DART AEROSPACE LTD	Work Order:	101941
Description: Crosstube Assembly (205/212 High Aft)	Part Number:	D212-664-241
Inspection Dwg: D212-664-241 Rev: D	Page 1 of 2

DRAWING NO. D212-664-241	TITLE CROSSTUBE ASSY (205/212 HI AFT)	REV. D	DART AEROSPACE LTD ENGINEERING ORDER		D.E.O. NO. D212-664-241-D-1	SHEET NO. SHEET 1 OF 2	SCALE NTS
DRAWN	CHECKED	MFG. APPR.	APPROVED	DE APPR.			
DATE 11.04.07	DATE 11.04.11	DATE 11.04.12	DATE 11/04/12	DATE 11.04.12

DRAWING NO. D212-664-241	TITLE CROSSTUBE ASSY (205/212 HI AFT)	REV. D	DART AEROSPACE LTD ENGINEERING ORDER	D.E.O. NO. D212-664-241-D-1	SHEET NO. SHEET 2 OF 2	SCALE NTS
DRAWN	CHECKED <i>CP</i>	MFG. APPR. <i>E</i>	APPROVED <i>MD</i>	DE APPR. <i>MD</i>		
DATE 11.04.07	DATE 11.04.11	DATE 11.04.12	DATE 11/04/12	DATE 11.04.12

DRAWING NO. D212-664-241	TITLE CROSSTUBE ASS'Y (205/212 HI AFT)	REV. D	DART AEROSPACE LTD ENGINEERING ORDER		D.E.O. NO. D212-664-241-D-2	SHEET NO. SHEET 1 OF 1	SCALE NTS
DRAWN 90	CHECKED ASS	MFG. APPR. 8	APPROVED MP		DE APPR. H4		
DATE 11.07.15	DATE 11.07.20	DATE 11.07.21	DATE 11/07/21		DATE 11-07-21

**D212-664-241/-241B
ASSEMBLY DETAIL**

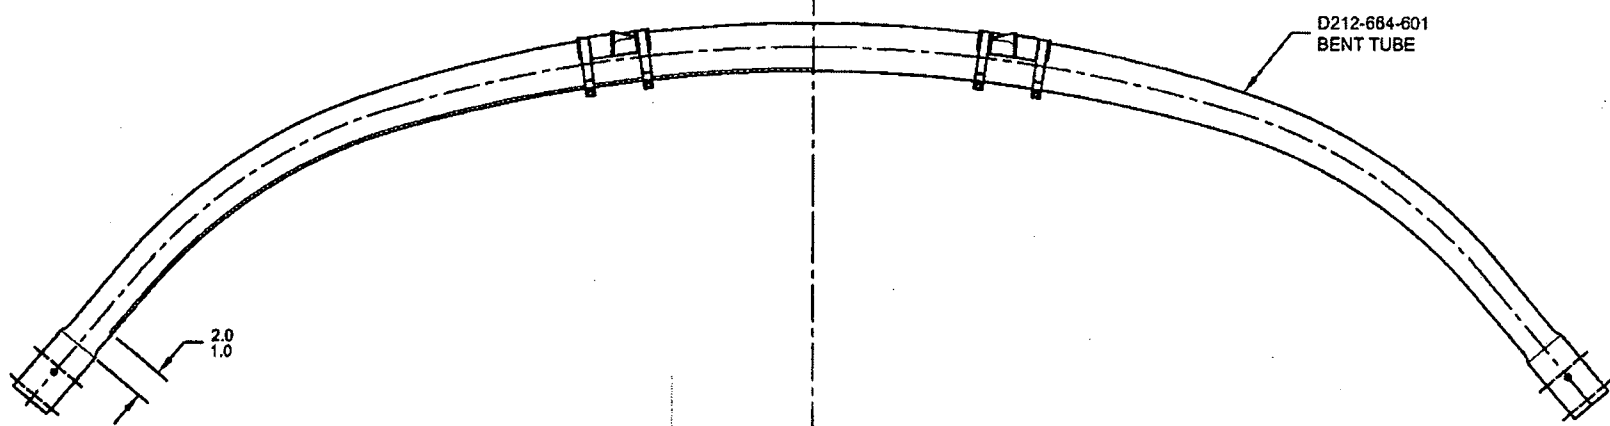
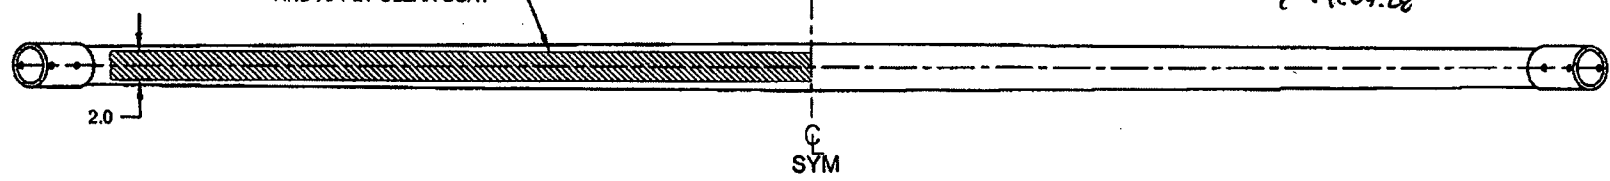
PURPOSE:

ADD AN INSPECTION WINDOW TO UNDERSIDE OF CROSSTUBE.

NOTES 2 OF SHEET 1 IS AMENDED AS FOLLOWS:

- 2) FINISH: CHEMICAL CONVERSION COAT PER DART QSI 005 4.1
PRIME INSIDE AND OUTSIDE PER DART QSI 005 4.2
MASK UNDERSIDE OF CROSSTUBE AS SHOWN (HATCHED AREA) AND
PAINT OUTSIDE PER DART QSI 005 4.2
REMOVE MASKING AND APPLY CLEAR COAT

MASK AREA PRIOR TO PAINTING,
REMOVE MASKING AFTER PAINT
AND APPLY CLEAR COAT
